Shop Drawing Review

CASA ROBLES 131
6545 SW STREET PINECREST,
FLORIDA 33156

FLOOR PLAN

WINDOWS AND DOORS

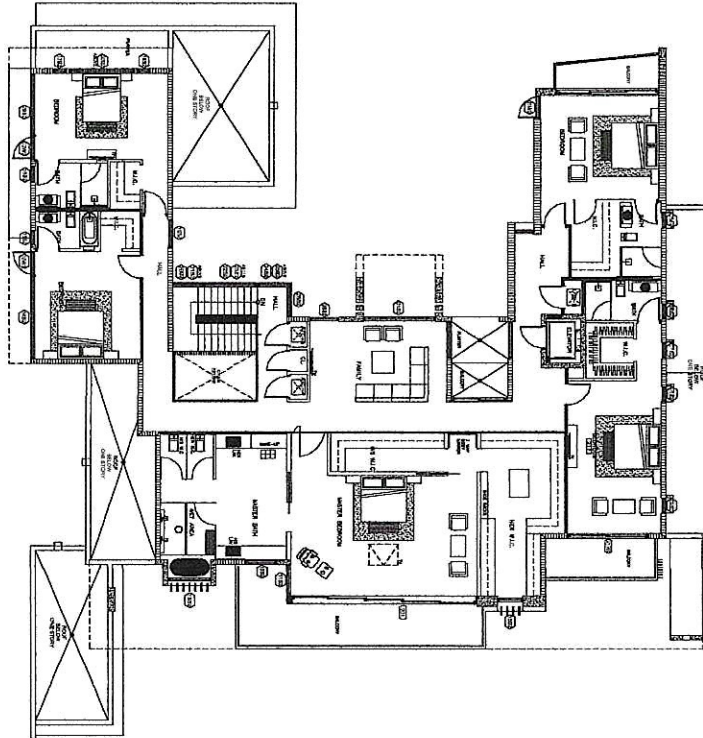
Reviewed only for compliance with wind loading criteria.

Windows values Approved before/after the Upgraded Energy Calculations Date
09-04-25 That Match With The Proposed Values In The Submittal.
